APPENDIX C
AREA WALK-BY CHECKLISTS (AWCs)

Area Walk-By Checklist (AWC)

Room 105 Floor El. 545 Bldg. AUXB

Photo 2
Missing Nuts on Cover of E31-4

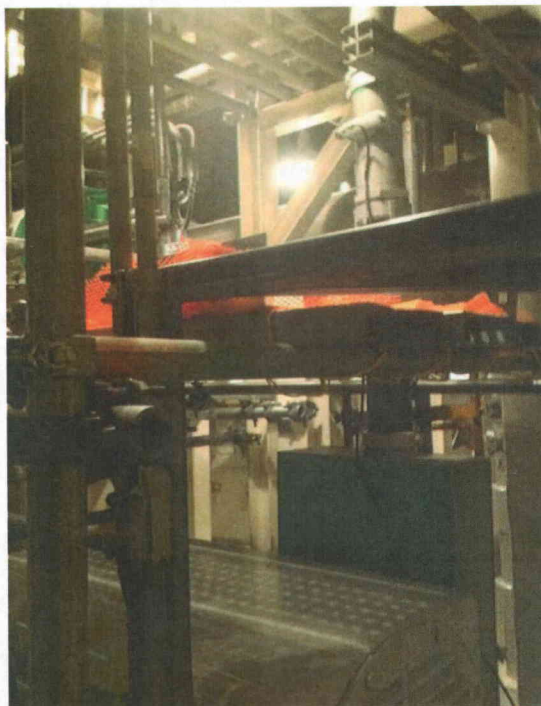
*Anchorage for cover plate of E31-4 does not have nuts, see Photo 2.
Concern has been judged not to represent an adverse condition regarding the component's seismic performance.*

Photo 2
Crack in Masonry Wall

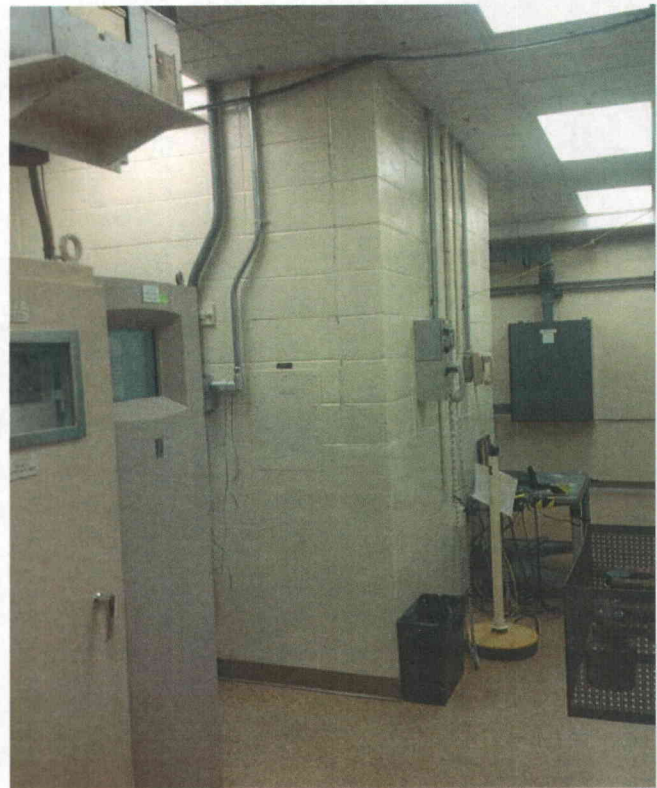
Masonry walls in area. Verify seismic adequacy of walls
